# UNITED STATES PATENT AND TRADEMARK OFFICE

APPLICATION NO.	FILING DATE	FIRST NAMED INVENTOR	ATTORNEY DOCKET NO.	CONFIRMATION NO.
10/717,974	11/21/2003	Bo Yeon Kim	9988.081.00-US	8004
30827	7590	10/03/2005	EXAMINER	
MCKENNA LONG & ALDRIDGE LLP 1900 K STREET, NW WASHINGTON, DC 20006			HANSEN, JAMES ORVILLE	
			ART UNIT	PAPER NUMBER
			3637

**Office Action Summary**

## **DETAILED ACTION**

REPLACEMENT SHEET

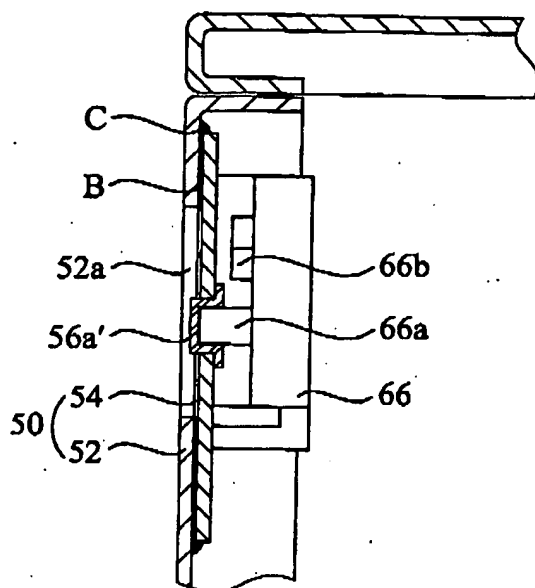
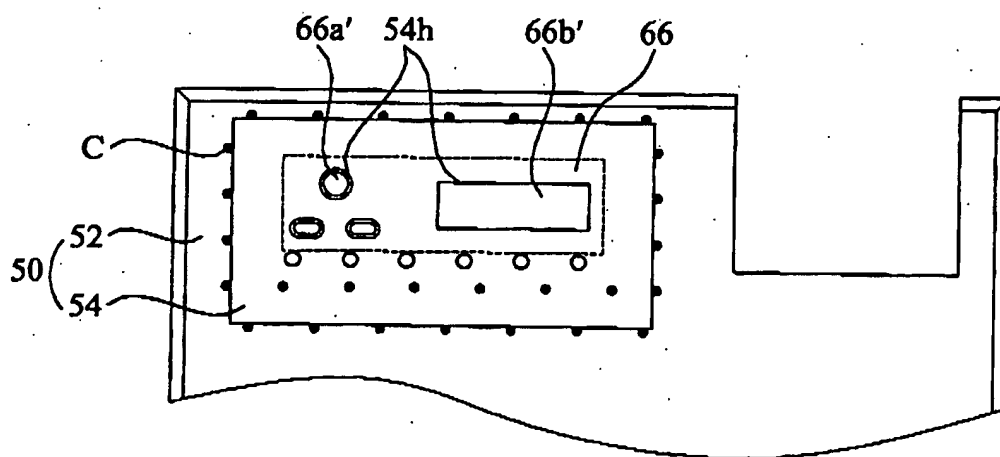
1. The drawings were received on July 20, 2005. These drawings are disapproved by the examiner for the following reason: after review and consideration, it appears that the proposed reference corrections may not be accurate. As currently amended, reference no. 66b is directed to the "display" and reference no. 66a is directed to the "controls". When comparing amended figure 5 with respect to original figure 6 [rear view of fig. 5 embodiment], it appears that the "controls" [66a] depiction is higher in elevation than the "display" [66b] depiction. When compared to amended figure 5, the referenced "display" would be higher in elevation than the referenced "controls". The examiner questions the referencing of the elements in question [should the references be reversed?].

Not Approved  
John 9/20/05
